E3631A-13D

S E R V I C E N O T E

E3631A DC Power Supply

Metal Strap Kit for tightening loose bumper and for fitting rear lock link in side-by-side rack mounting

Figure 2: Top view 3mm gap observed between two different chassis designs

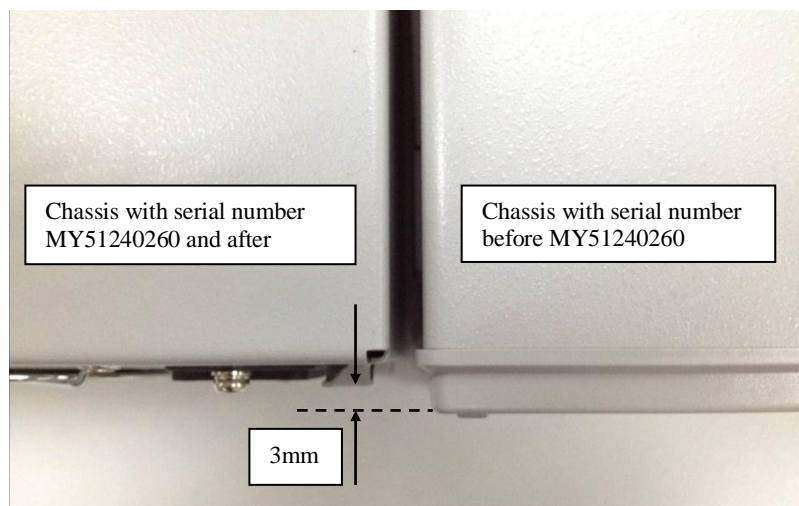
The chassis depth difference between the two designs is 3mm as shown in Table 1 and Figure 2 below.

Use metal strap (part number E3631-07901), and stack the provided two metal straps together to form 3mm thickness and secure it with the provided screws on the rear lock link as shown in Figure 5 below.

Figure 3: Top view 3mm gap observed on rear lock link for side-by-side rack mounting

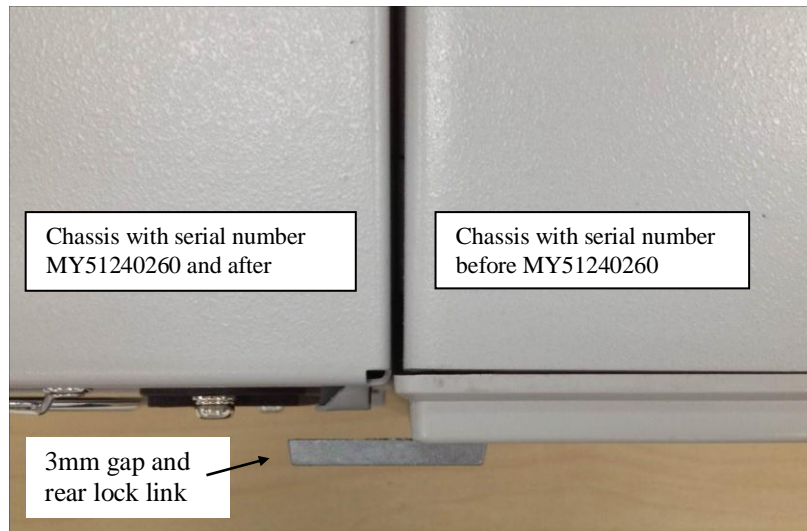
The 3 mm gap between the two different chassis may cause difficulties in securing them together using a rear lock link kit (part number 0050-2167) for side-by-side rack mounting as shown in Figure 3 below.
